STATEMENT OF MODIFICATION

MODIFICATION TO 596 No. 282/14
FOR POOL & SPA

20 SUNRISE RD
PALM BEACH

Image 1 – View north across existing garden area to the rear of residence, being the area for the proposed swimming pool, poolside areas and spa.

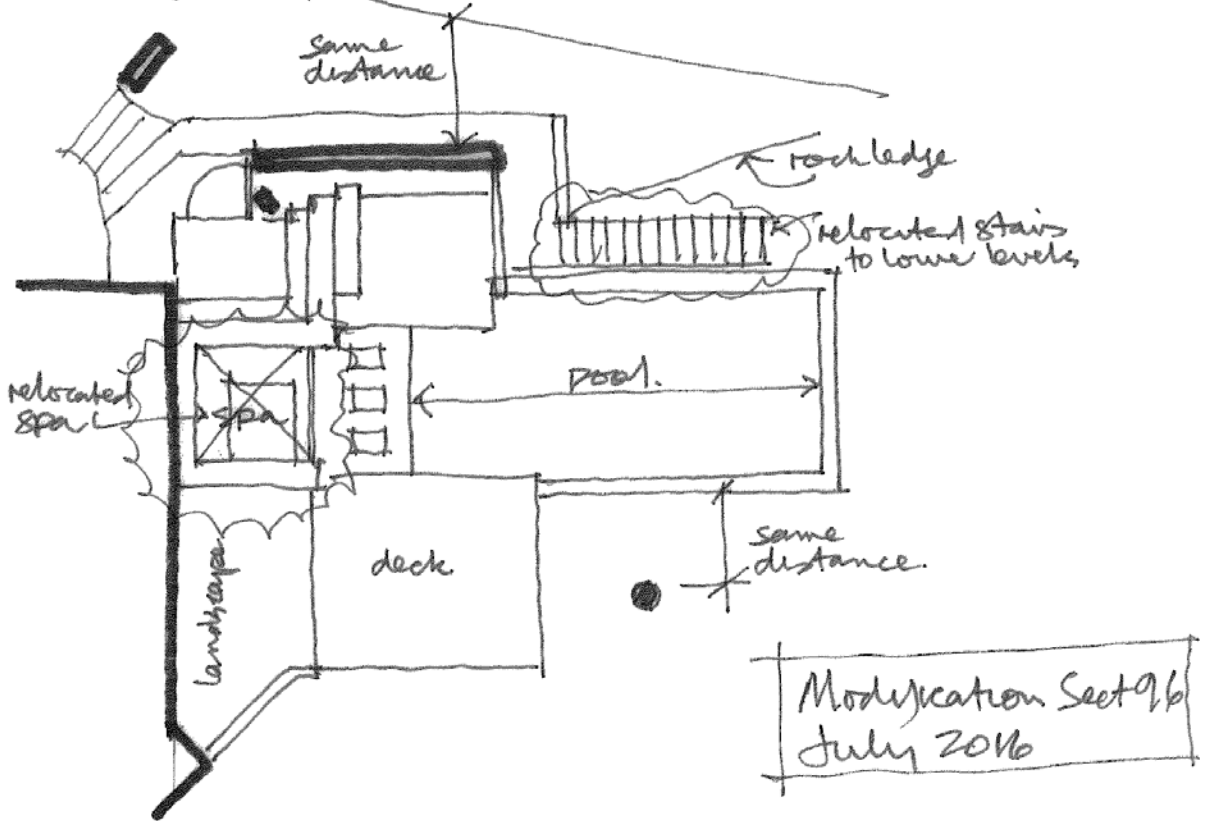
1. Relocation of the spa to the west side of the pool from the north side.
2. Relocation of access to the lower site levels to the north side of the pool from the south side.
3. Reduction of glass edges to the pool: now east side only.
